Initial Project Review

Preliminary Short Plat / Environmental Review: Silverbrook

Application Numbers: 992537, 992538
Parcel Number: 0419295001

Proposal: Subdivide a combined 4.75-acre 4 parcel site into 16 residential lots with a stormwater tract and a cell tower tract.

Silverbrook Plat Drawings

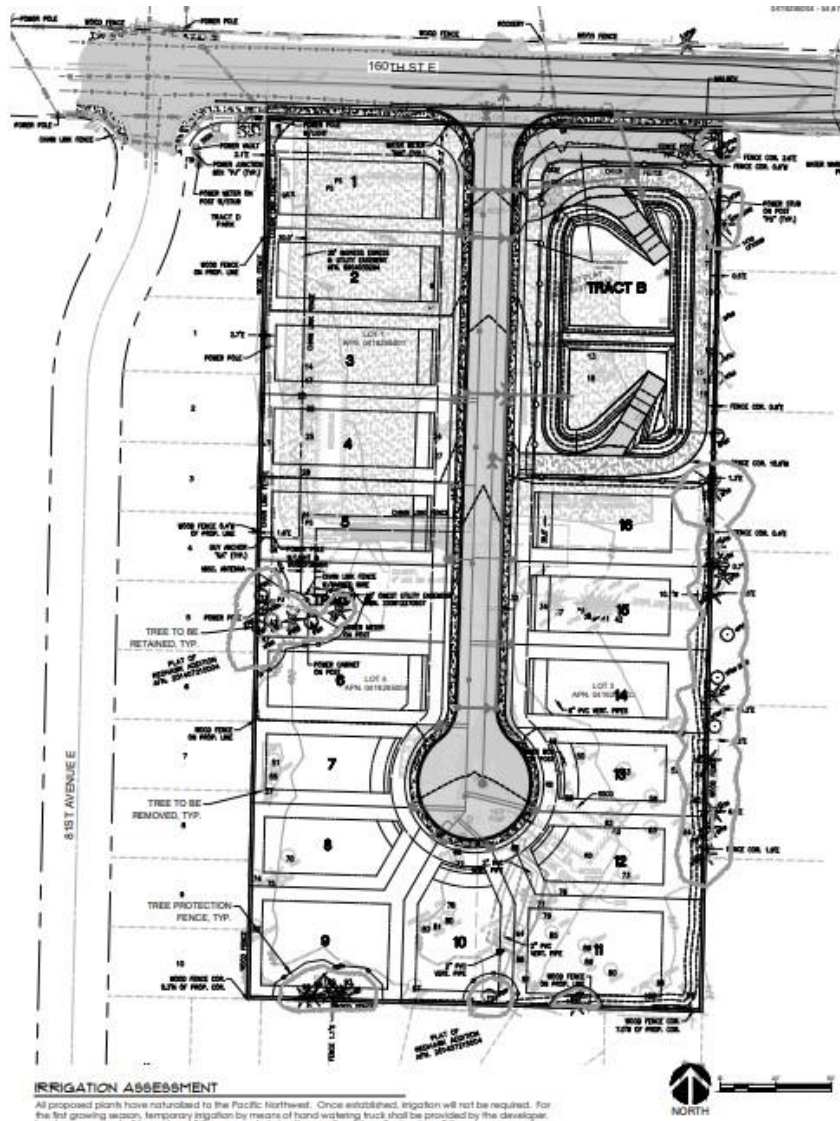
1. Cartography currently has a request to modify the survey by adding a road name.

3. Development Engineering reviewed the preliminary drawings and sent the applicant the required revisions via email and have submitted a Right of Way Letter, dated August 22, 2022.

5. Fire Prevention requested hydrants, stated requirements for fire sprinklers, and have provided a list of notes to be placed on the plat.

8. Bethel School District requested the bus stop be located at the west side of the entrance on 160th Street East, with a sidewalk for students to stand on while waiting for bus pick up service.

Staff Comment: Along the eastern property boundary a 30-foot rear yard setback and a fence are required and a note stating as much is required on the face of the final plat.
